E8358A-02E

S E R V I C E N O T E

E8358A PNA Series RF Network Analyzers

Serial Numbers: 00000000 thru 46999999

Figure 1

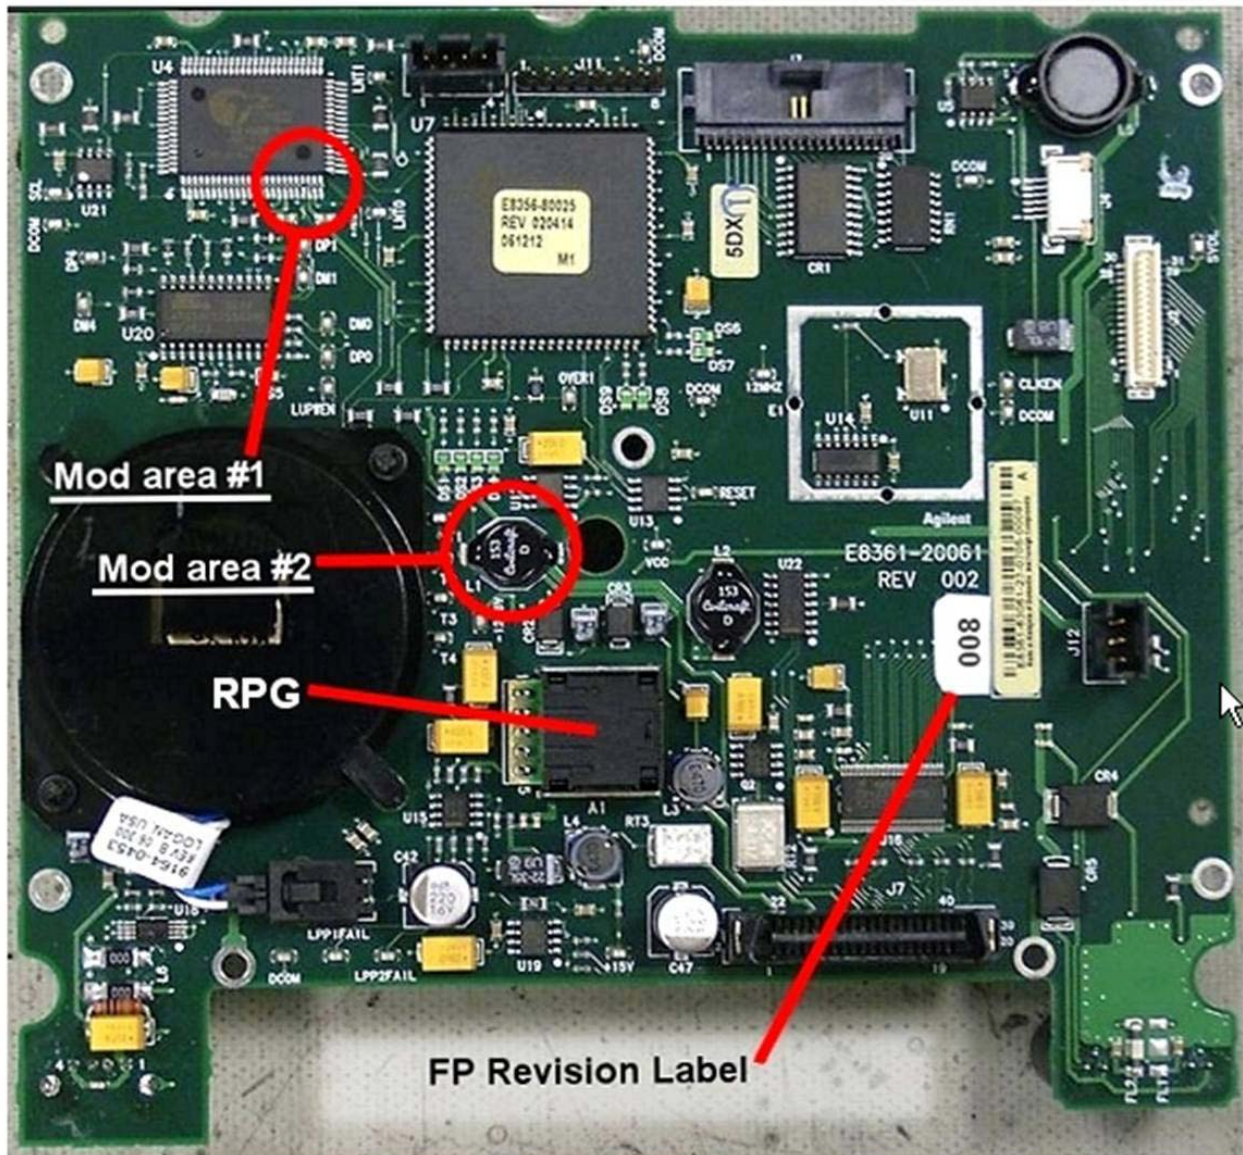
Refer to Figure 1 for the two modification areas to be addressed. Note that while this picture happens to show the FPI board completely removed from the front frame assembly, this is not necessary to perform the required modifications.

- Modification #1 consists of shorting two pins of U4 together with a small amount of solder.
- Modification #2 consist of removing L1.

Figure 2

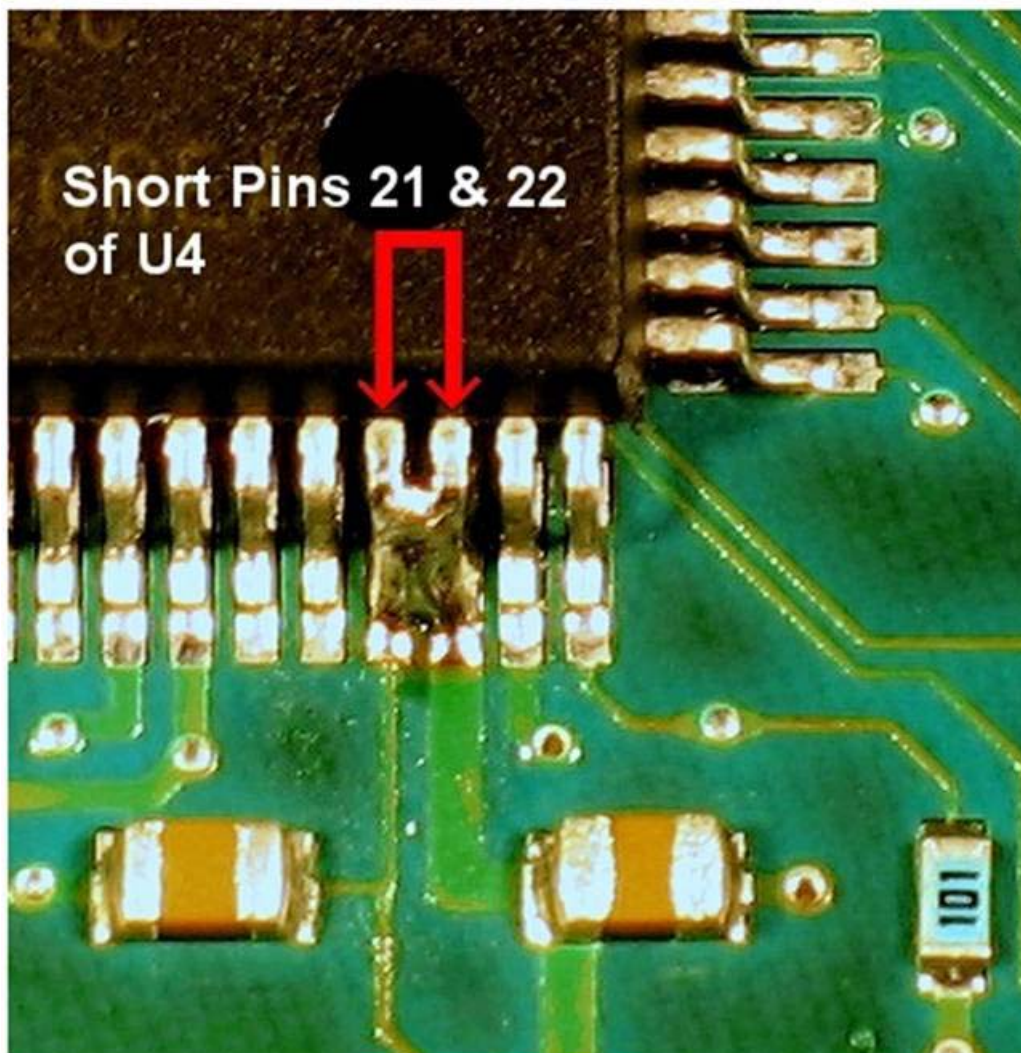
Carefully solder pins 21 and 22 together on U4. Refer to Figure 2 for the exact location. Use care so that no other pins are shorted. Use of a very fine tip soldering iron is recommended and a large work-task magnifying glass is very helpful.

Unsolder and completely remove the black surface mount inductor L1 from the front panel assembly board. This is no longer needed and can be discarded.
